LAND DEPARTMENT.

Plot No. 24, A-9, Old Town Quarter.

Subject Strengthening Beams

AMENDED
PLAN OF BUILDING ON PLOT 24
SHEET NO A-9
OLDTOWN QUARTER
SCALE 4"=1" INCH

PART PLAN OF SHEET NO.

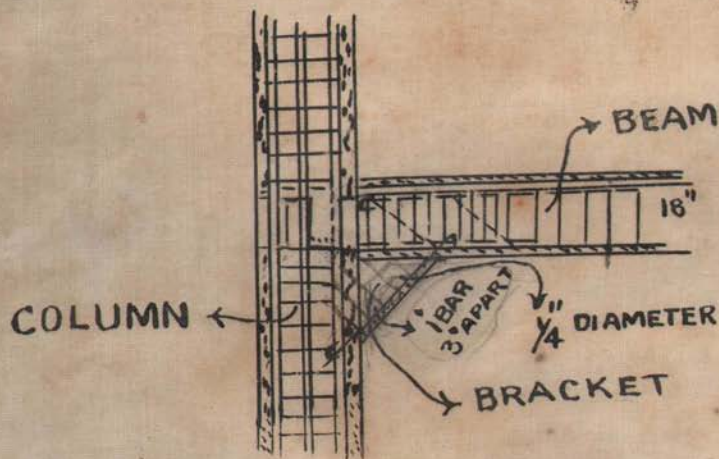
The silo was inspected
when the owner's architect
was present. The size of the
beam was taken: 12" x 8"

The owner and the architect
agreed to put up the
bracket as explained.

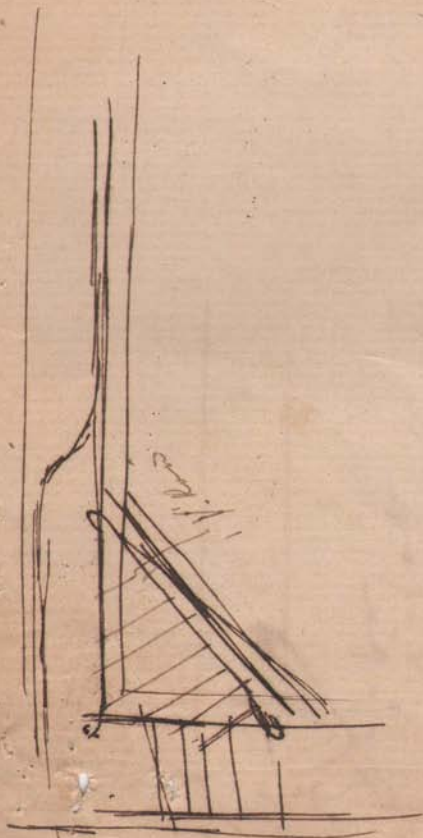
With reference to the interview of your architect, Mr. Asarpota when Dr. Hotchand was present, the arrangement arrived at was that you have agreed to strengthen the beams which are weak in the following way.

For beams marked ~~1-1-1~~ ^{G. 101} on plans sent herewith you will have a reinforced concrete bracket fixed as shown in the sketch.

The drainage connection was given on the clear understanding that you will carry out these suggestions, failing which it will be cut off.

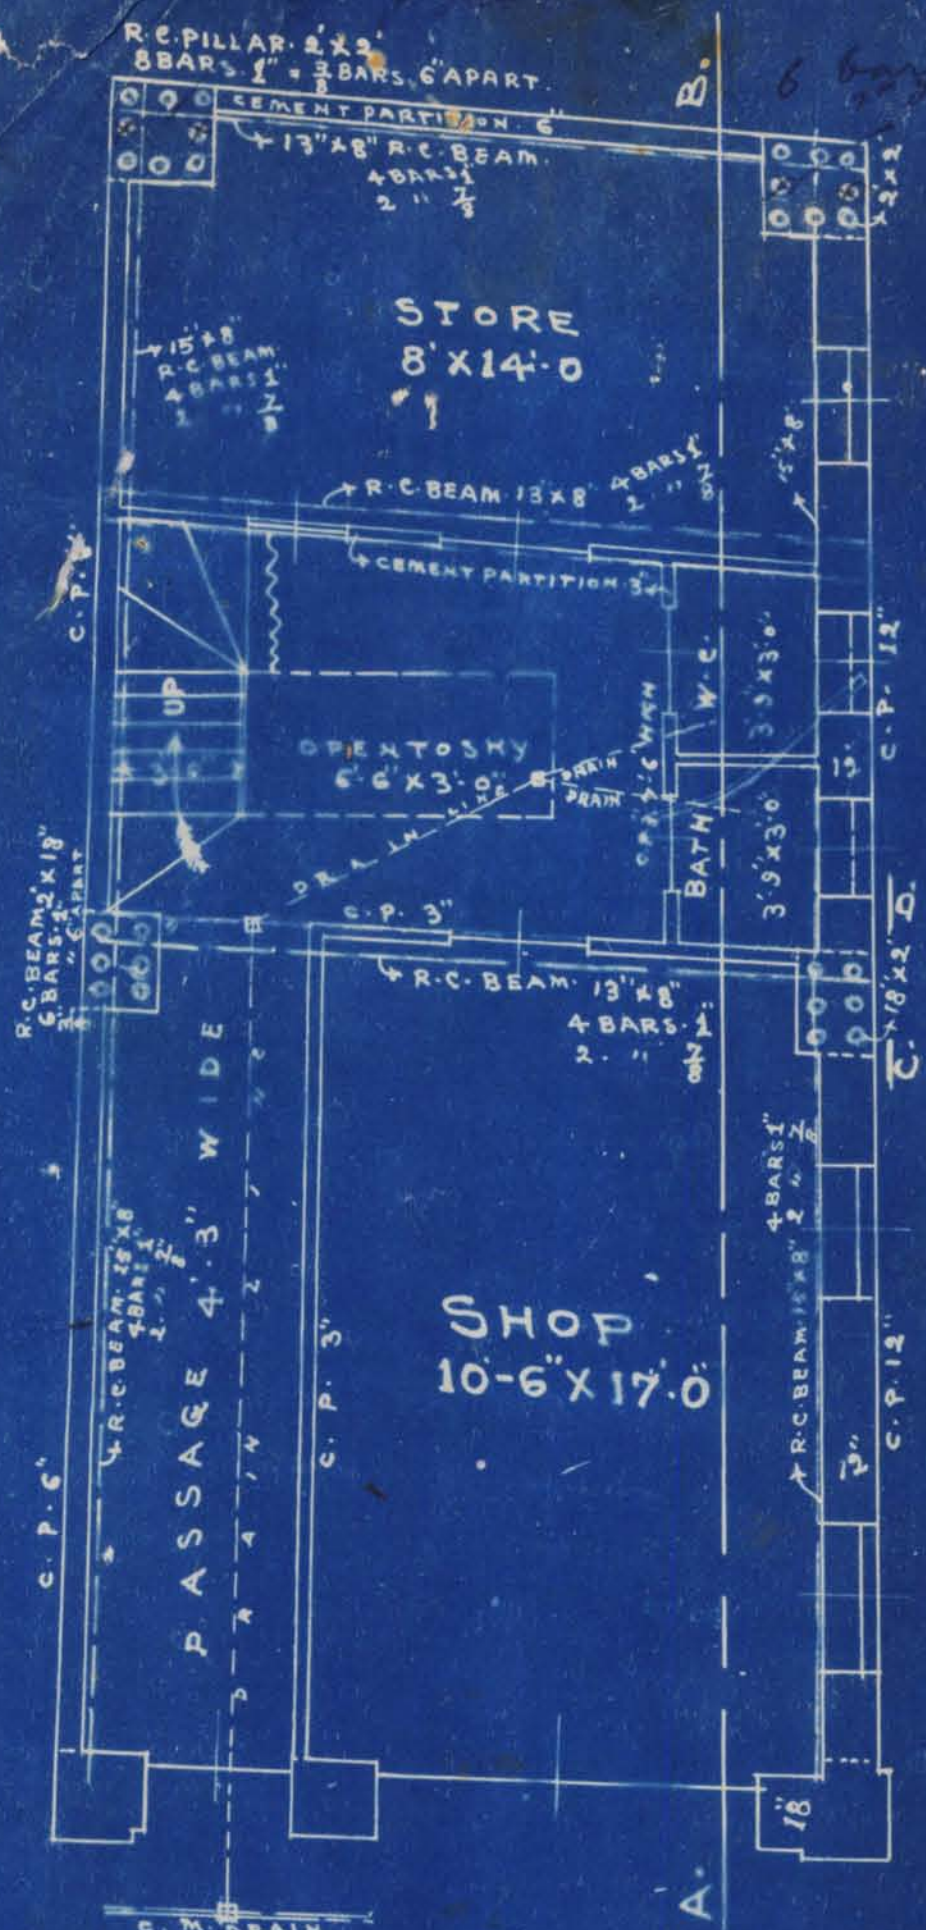
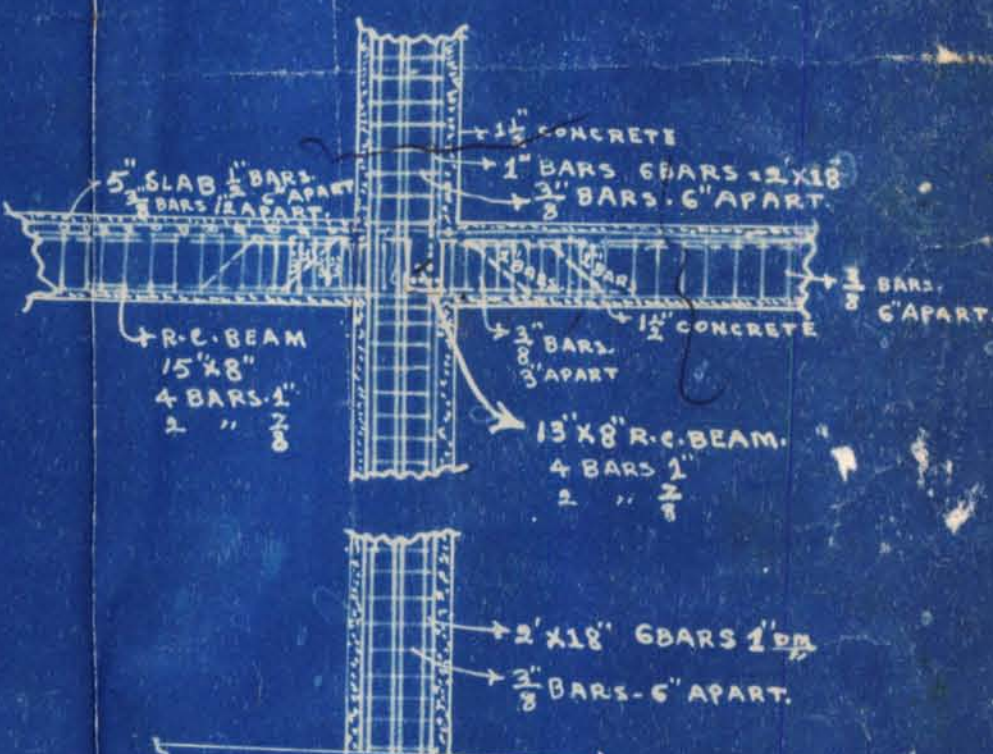
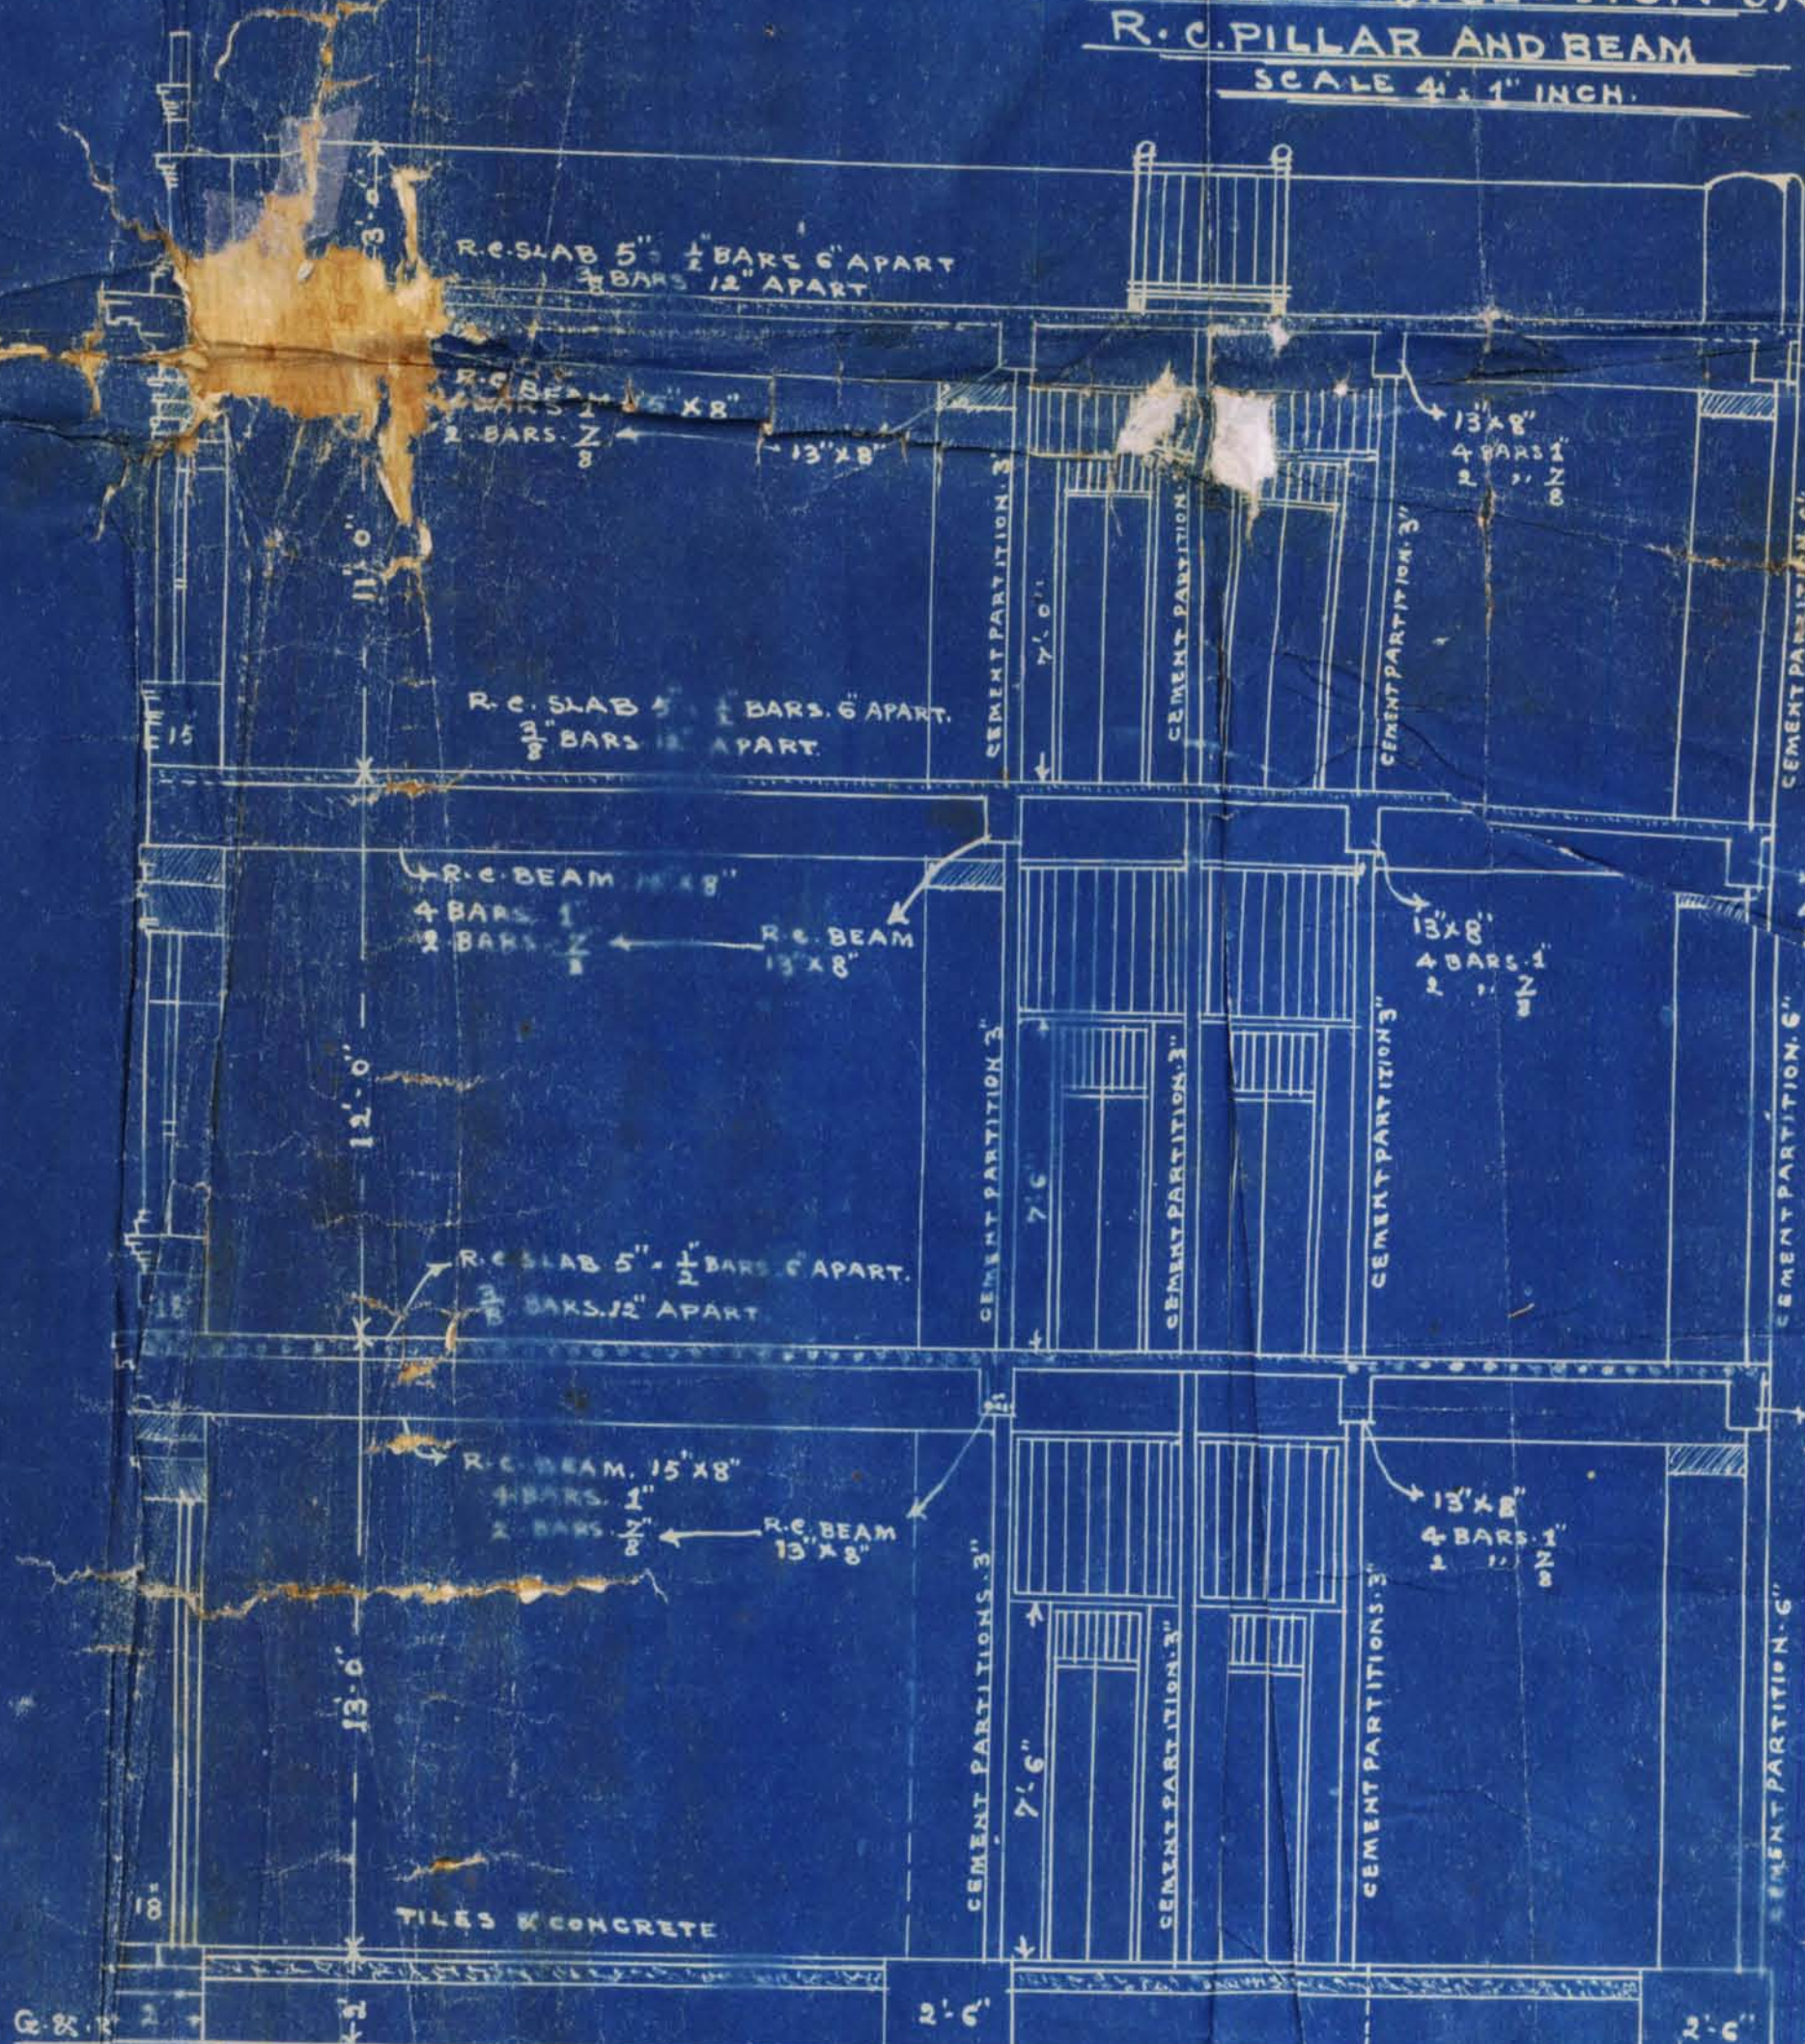
According to the reinforcements seen on site and the size of the beam mentioned in the plans submitted it seems that the beams, provided are weak.

- (1) The structure requires full thickness of the walls as shown on original plan approved.
- (2) Thin walls are not ~~not~~ allowed.
- (3) Open area is insufficient.
- (4) You have carried out the work without authority for which you are liable for prosecution.
- (5) Portion under acquisition is not properly dimensioned.
- (6)
- (7)
- (8)
- (9)
